**Pacific Gas and
Electric Company™**

**Re: Estrella Substation and Paso Robles Area Reinforcement Project (A.17-01-023) –
Pacific Gas and Electric Company Comments on Draft Alternatives Screening
Report**

Pacific Gas and Electric Company Estrella Substation and Paso Robles Reinforcement Project (A.17-01-023)

Comments on Specific Alternatives Presented in Alternatives Screening Report

Figure 1: Proposed Project 70 kV Reroute

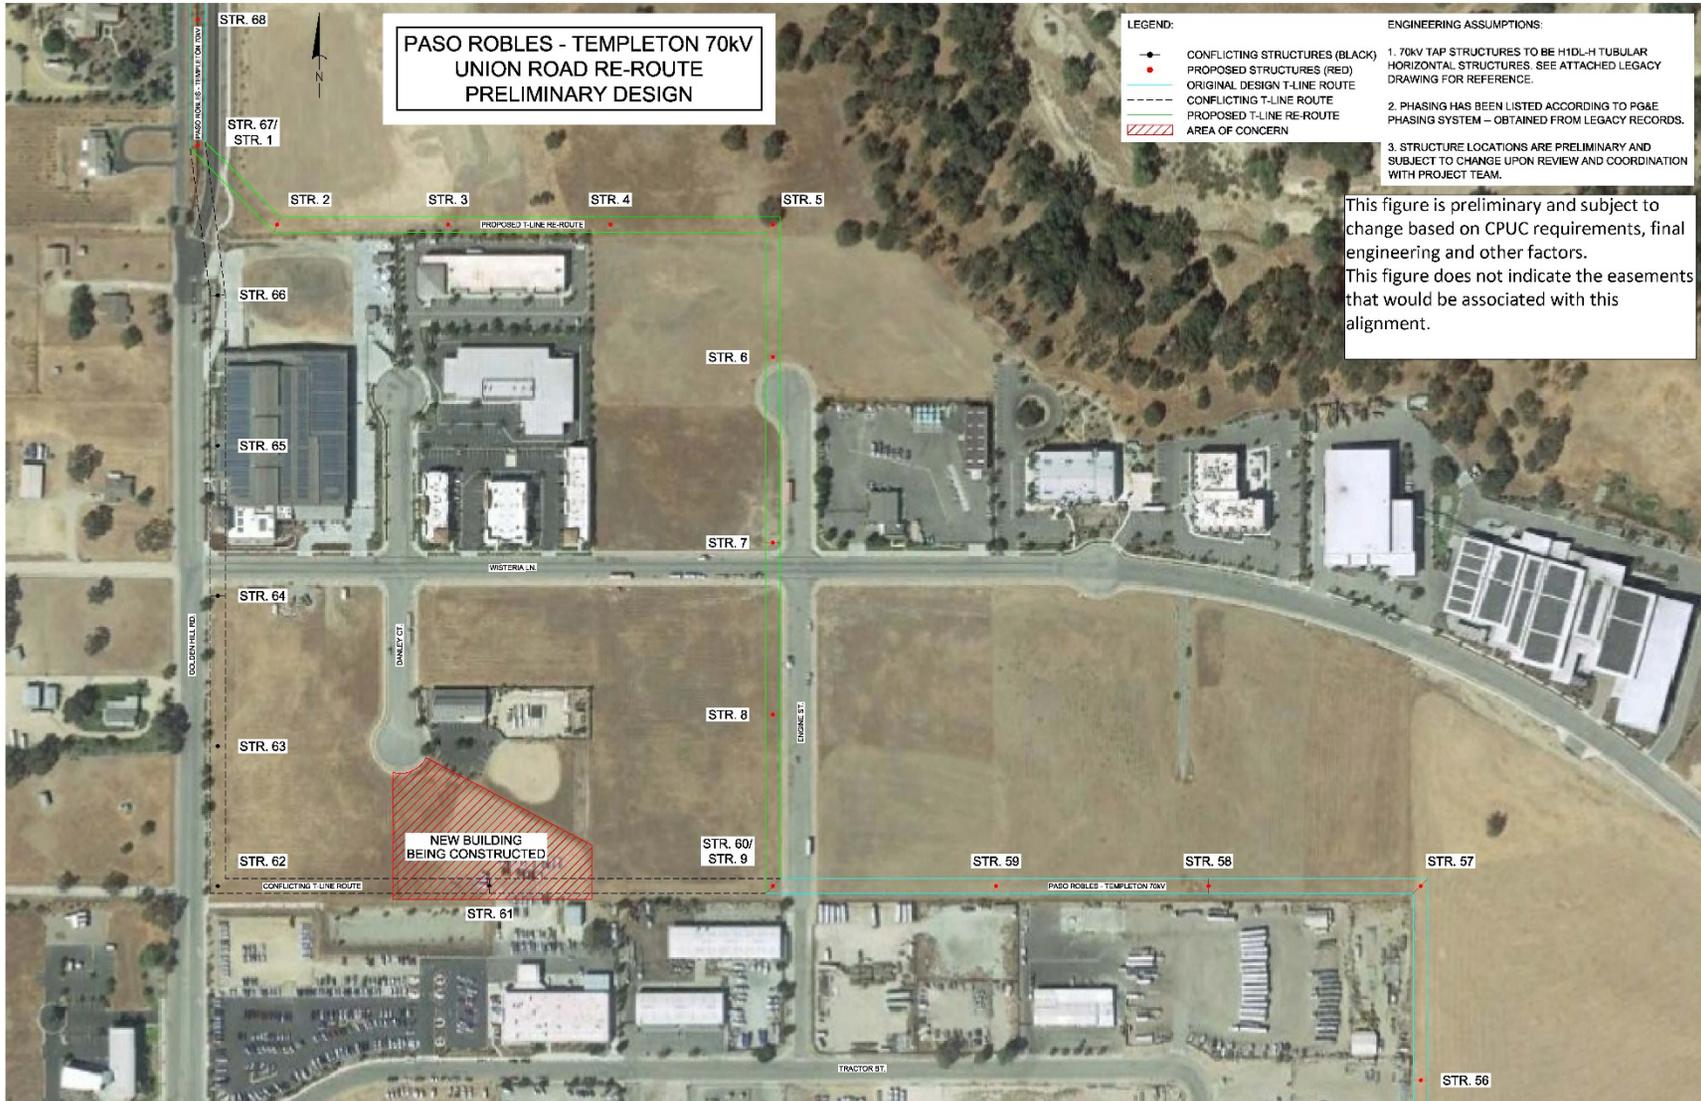
During a recent walkdown of the Proposed Project 70 kV route, we discovered that a portion of our proposed overhead double-circuit transmission line route that would run through the Golden Hill Industrial Park will need to be re-routed to address a new construction project currently underway on Tractor Danley Court Street between Germaine Engine Street Way and Golden Hill Road. We propose to make a minor modification to the proposed overhead routing of the new transmission line as outlined in blue in Figure 1. We note that this slight change to the routing of

the overhead line would place it out of the direct view of the San Antonio Winery tasting room. Also, this new construction project would impact the routing of PLR-3 as shown on Figure 3-6 of the ASR.

Figure 2: Paso Robles Substation Summer Peak Load (MW) and the Transmission Capability During P1 Contingency (Loss of Paso Robles-Templeton 70 kV Line)

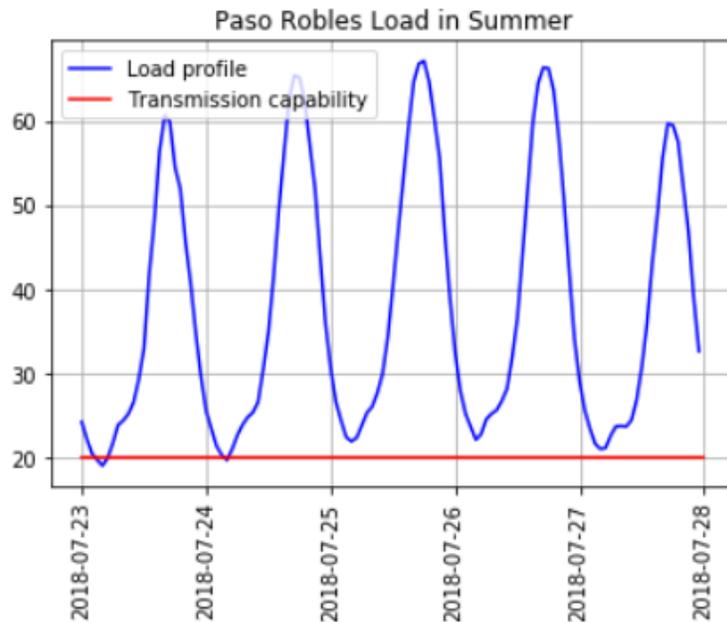
A simple power flow analysis shows that under the P1 contingency involving an outage of Templeton-Paso Robles 70 kV transmission line, the Paso Robles substation can support at most approximately 20 MW of load (see Figure 2) before reaching the thermal limit of the Coalinga-San Miguel 70 kV transmission line.

According to load data at Paso Robles Substation, the load is higher than the available transmission capability (under the P1 contingency above) even in the night during the summer peak period (see Figure 2). Meanwhile with the battery alternative, the transmission capacity will not increase but the load will increase in the future. This situation will make charging the BESS infeasible. Following the current operational standard, the system should be operated to secure N-1 outages (P1); i.e., if a P1 contingency were to happen, there should be no violations without system adjustment. In order to meet this standard, the BESS has to discharge once the load is higher than 20 MW to make the system N-1 secured. According to the real-time data

shown in Figure 2, there will be no charging window or not enough charging window in multiple days during the summer peak period after discharge if the battery energy requirement is for 24-hours only.
